Technical Service Bulletin: TSB120250

New QSK45/60 Tier 1 Exhaust Gas Temperature Sensor Harnesses

Figure 1. Original Connector Location

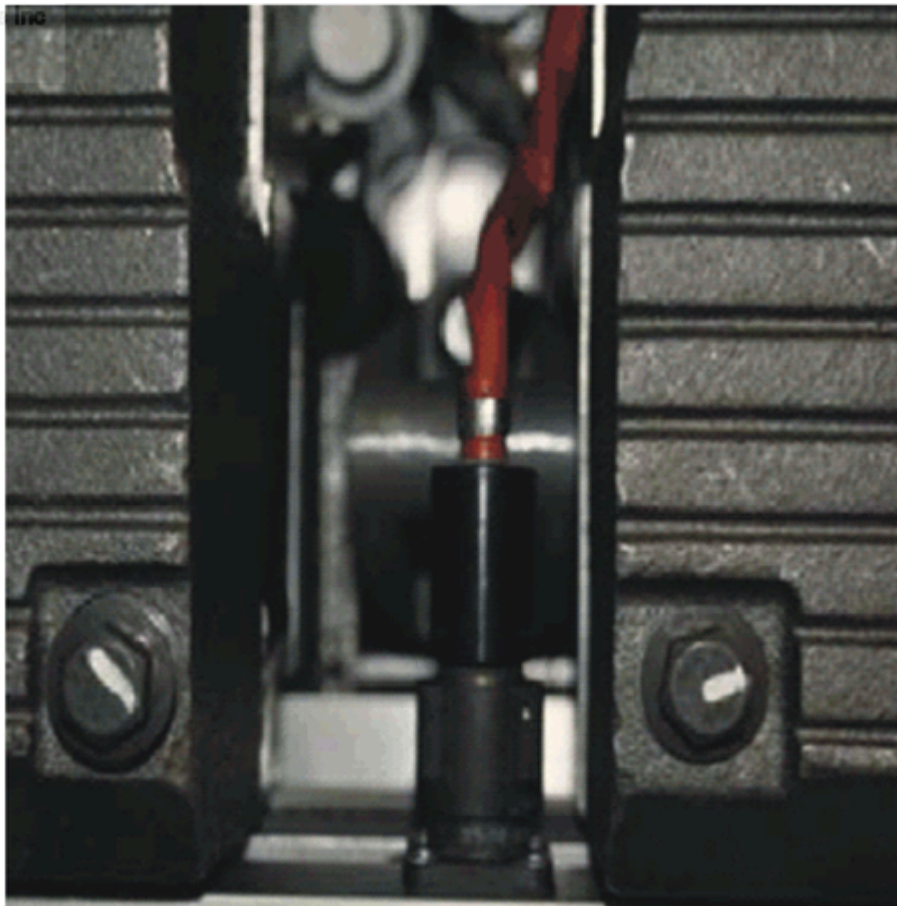
This document announces the release of new exhaust gas temperature sensor (EGTS) harnesses for Tier1 QSK45 and QSK60 engines. It was determined that damage could be caused to the EGTS harness when lifting the engine, due to the proximity of the lifting bracket to the EGTS connectors. This issue has been resolved by moving the connectors away from the lifting bracket.

The photographs show the original connector location (Figure 1) and the revised connector location (Figure 2).

Note : The new EGTS hardware is not backward compatible with some previous versions. Therefore, previous versions will continue to be available to service to allow repairs to be completed without requiring a complete hardware change. New and old hardware can be mixed within an engine. On the QSK45, for example, one bank can be new hardware and one bank can be old hardware.

The new EGTS hardware went into production at Daventry Engine Plant on 10 September 2012, engine serial number (ESN) first 33195022.
